Staff Report

To: BOZAR
From: Jessie Earley, Town Planner III
Meeting Date: DRC, May 12, 2025
RE: 2 Teocalli Avenue (Felton), Final Review

PROJECT TITLE: Felton (2 Teocalli Avenue)

SUMMARY: Consideration of the application of **Edward L. Felton, Jr Trust Dated 12/28/1999** to site an addition to the primary building and to construct a cold accessory building to be located at 2 Teocalli Avenue, Lots 15 and 16, Block 7 in the R1 zone.

5/12 DRC and 5/27 BOZAR: Proposed Site Plan

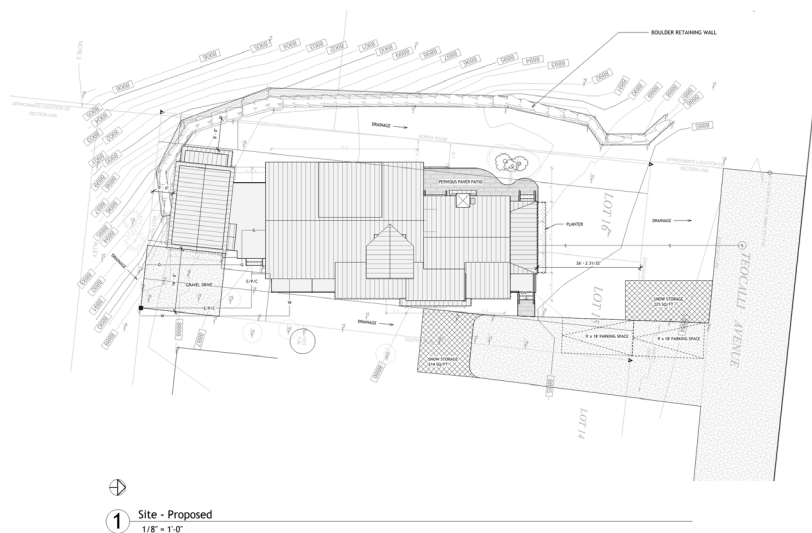
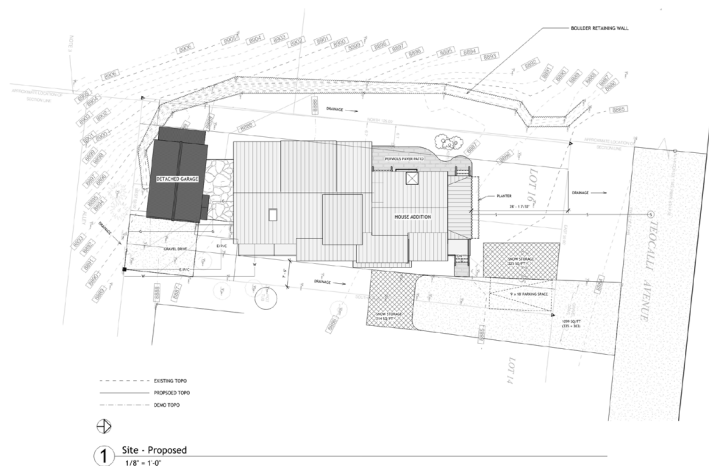
Adjacent rights of way have been included to-scale.	
2.7 Snow Storage	Snow storage is provided onsite and now meets the 33% requirement of the areas to be plowed. However, it is not adjacent to these areas for the area in the rear (south).	Provide information. The applicant has shifted the areas.

- The following information must be added to the site plan prior to permitting:
 - Two street trees
 - Ground cover for disturbed areas
 - Snow storage area adjacent to the parking area on the south

5/12 DRC: Revised North Elevation

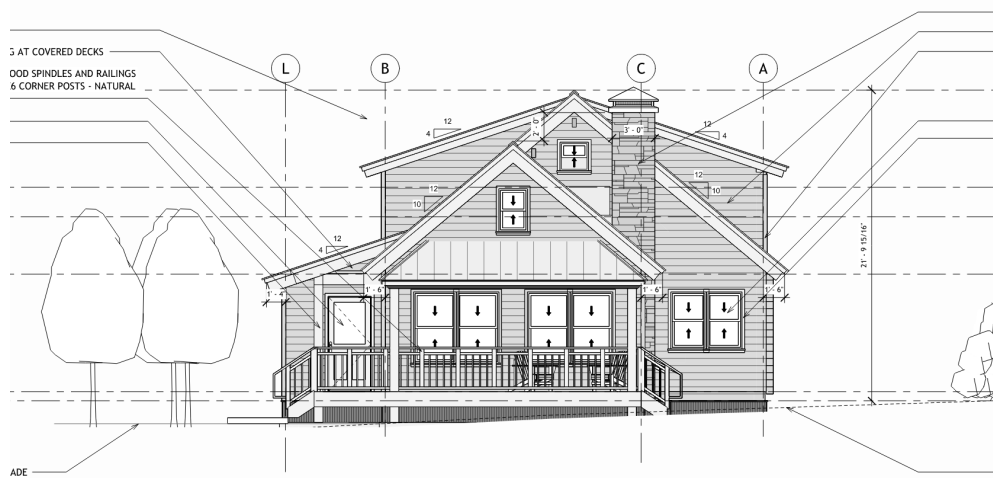
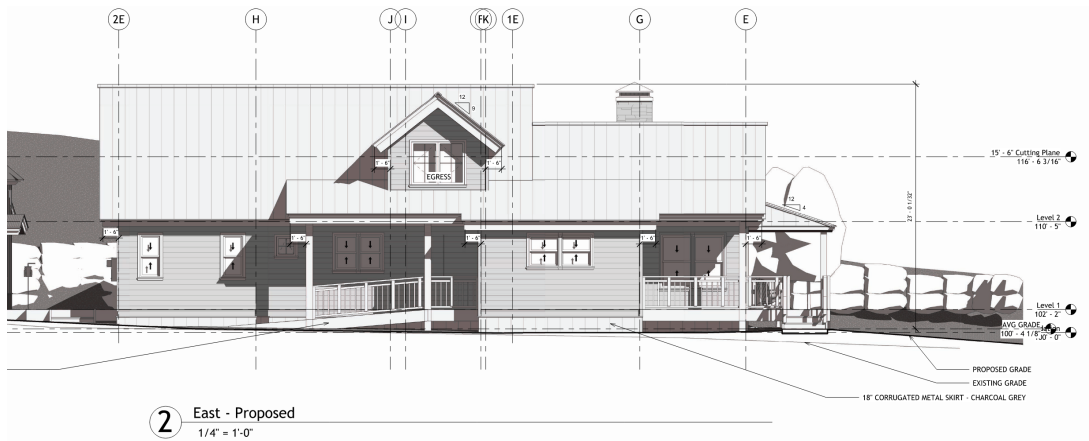
- Reduced the size of the west-facing dormer to be less than 30% of roof area.
- Changed the east dormer to a shed dormer to match the west dormer.
- Reduced the size of the chimney. Brought chimney in below roof to avoid odd roof extension. Moved stack slightly to north to provide code clearance.
- Changed railing to wood.
- Moved parking and snow storage onto property.

5/12 DRC: Revised West Elevation

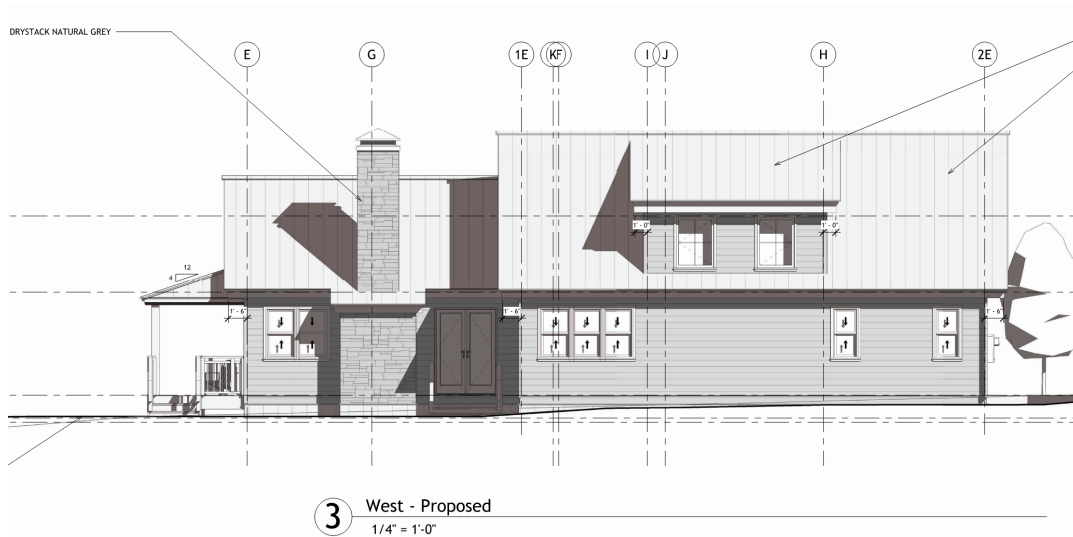
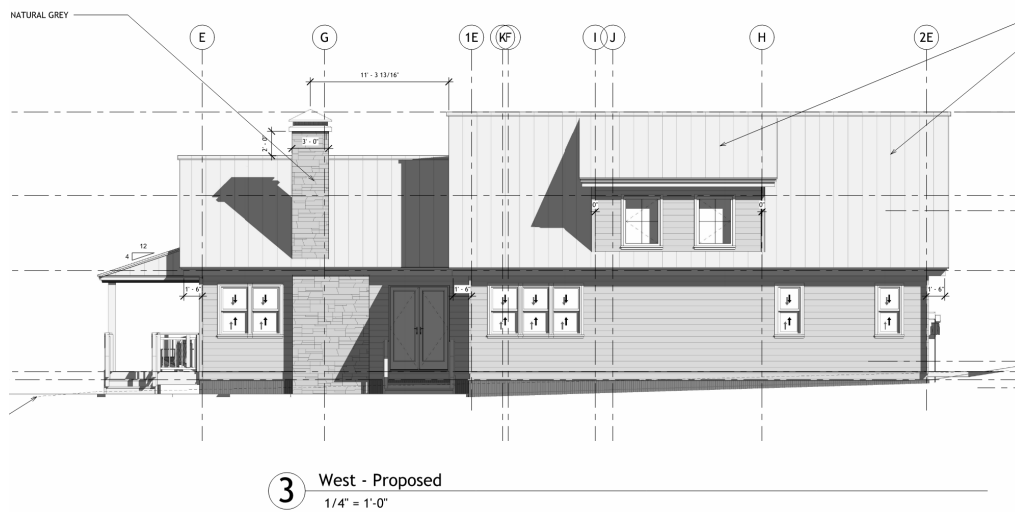
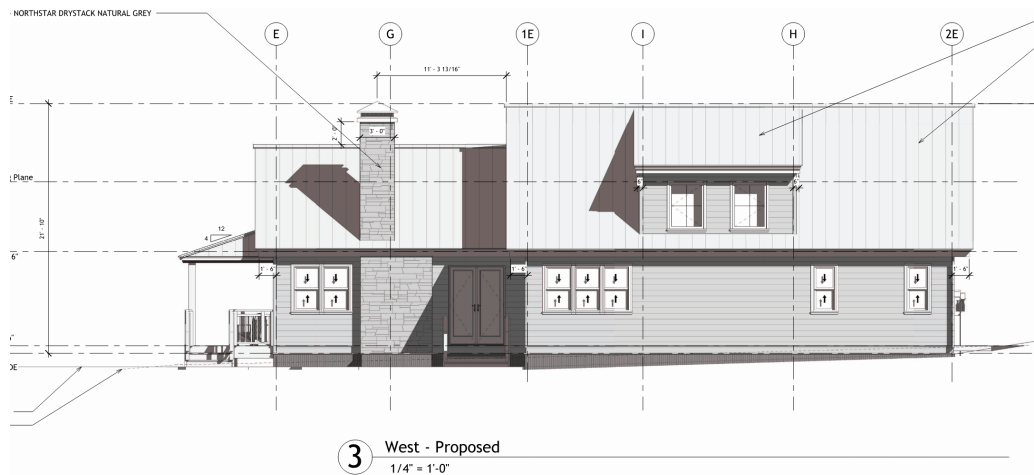
4.47 Dormers	<p><u>West shed:</u> The dormer steps down 8” from the ridge of the module but appears large on this elevation.</p> <p><u>East shed:</u> The dormer steps down 8” from the ridge of the module and achieves subordination.</p> <p>a. <u>West shed:</u> The dormer, as proposed occupies 29.5% of the roof, which now supported by this GL that requires 30%.</p> <p><u>East shed:</u> The dormer, as proposed occupies 20% of the roof, which is supported.</p> <p>b. <u>West shed:</u> The dormer is lower than the ridge. There is a section of roof beneath, support.</p> <p><u>East shed:</u> The dormer is lower than the ridge. There is a section of roof beneath, support.</p> <p>c. NA.</p> <p>d. <u>West shed:</u> The dormer as proposed is in the middle 70% of the roof form.</p> <p><u>East shed:</u> The dormer is proposed within the first 1/3 of the roof, not the middle 70% as the GL suggests.</p> <p>e. <u>West shed:</u> The vertical wall of the dormer is 5’4”. This must be reduced to 4’ to meet the intents of the GL.</p> <p><u>East shed:</u> The vertical wall of the dormer is 4’4”, which also must be reduced slightly to meet the intents of the GL.</p>	<p>4/21 DRC: Members did not support the mix of dormers. So, the applicant revised the proposal for two shed dormers.</p> <p>5/12 DRC: Support</p> <p>Members also asked for the dormers to be revised to ensure compliance with the 4’ vertical wall requirement.</p>

GL	Staff Analysis	DRC Recommendation
4.71 Chimneys	<p>The chimney does not exit from the ridge, as seen historically.</p> <p>The chimney is 3' x 3' at the top as it exits the lower part of the eave on the west. Then, the base of the chimney is increased in size to 6'3" width as seen from the west. It does not appear as chimneys were seen historically. Discussion is encouraged if it can be supported due to the location on the side elevation.</p>	<p>4/21 DRC: Members asked for revisions to the chimney, as it appeared to conflict with the GL. The applicant has provided revisions.</p> <p>5/12 DRC: Members again voiced concern regarding the chimney as proposed.</p>

5/12 DRC and 5/27 BOZAR: Elevations glazing

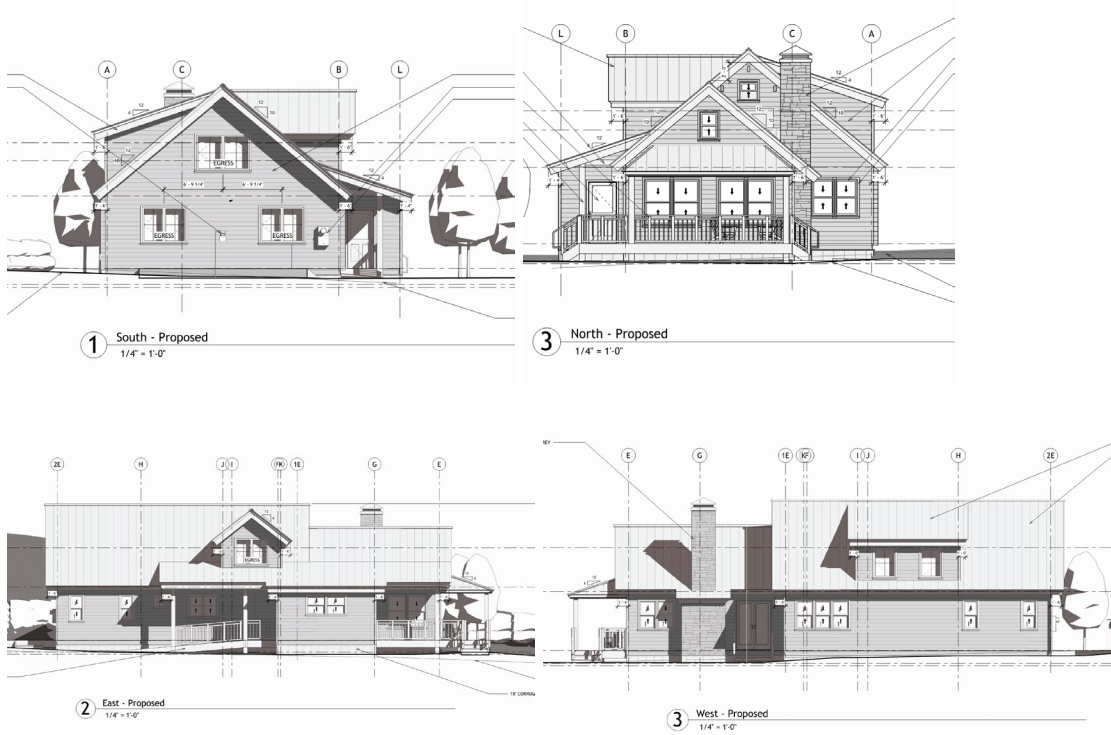
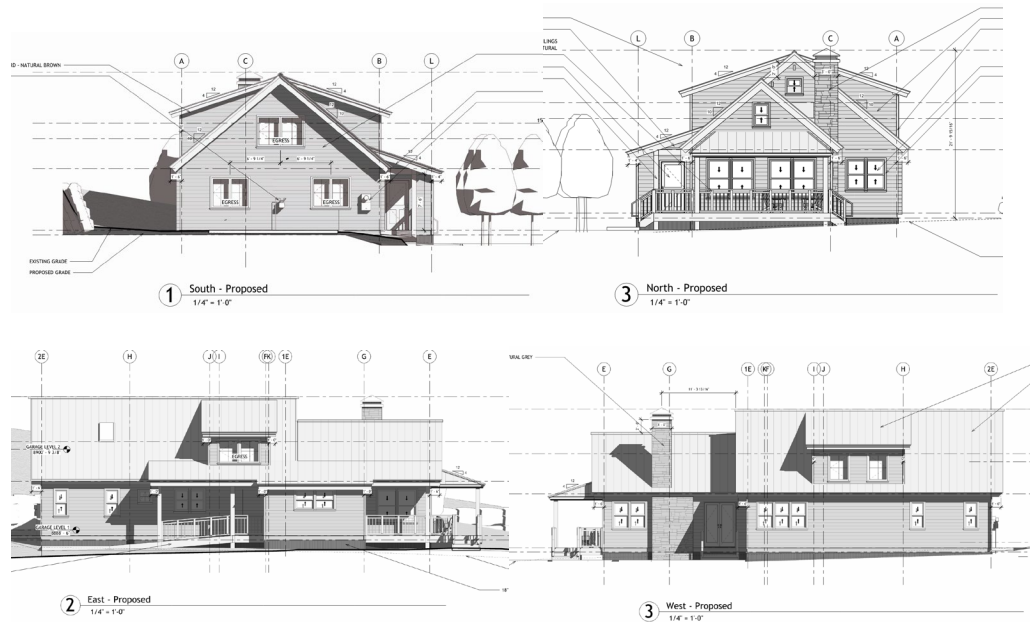
4.54 Vertical emphasis	<p>Some windows are proposed as two over two, and others are proposed as a one over one. One style should be chosen. Windows are double hung and double hung style casement windows, which is consistent with historic homes. A window schedule has not been included but should be.</p> <p>The windows are proposed as casement and double hung, which is supported by GL 4.54 a. Window operations have been noted on the plans. These windows must have simulated divided lights, which are noted on the plans and materials list.</p> <p>A limited number of small square windows are allowed per GL 4.54 c and there is one window on the east elevation. This meets the intents of this GL.</p>	4/21 DRC: Choose one style of window one over one or two over two.

4.58 Groupings of 2 or more windows	<p>All three packs of windows must have 3.5" of dividing trim because this is a core zone. These windows cannot be mullied. This must be revised for the three pack on the west elevation.</p> <p>The two packs on all elevations appear to meet the intents of this GL.</p>	4/21 DRC: Provide 3.5" of trim for west three pack of windows

Figure 3. Heights and magnitudes in psf (pounds per square foot) are shown on sheet A06 of the AHA drawings. 100psf loads appear on north views and west views.

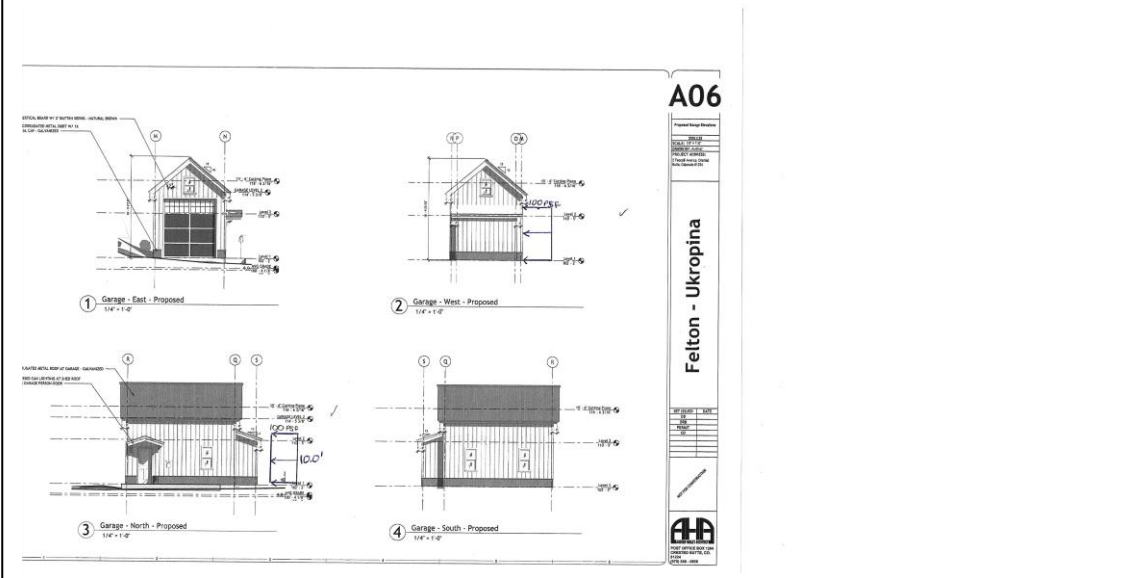
proposed garage will require mitigation from a uniform avalanche impact load of 100 psf over the 10-foot height starting at the finished ground surface. The 10-foot height assumes varying snowpack heights on the ground when the avalanche occurs. This 100psf should be treated as an impact load that rises from zero to 100psf in 0.3 seconds. An impact factor depends on structure response to the load and must be determined by the structural engineer.
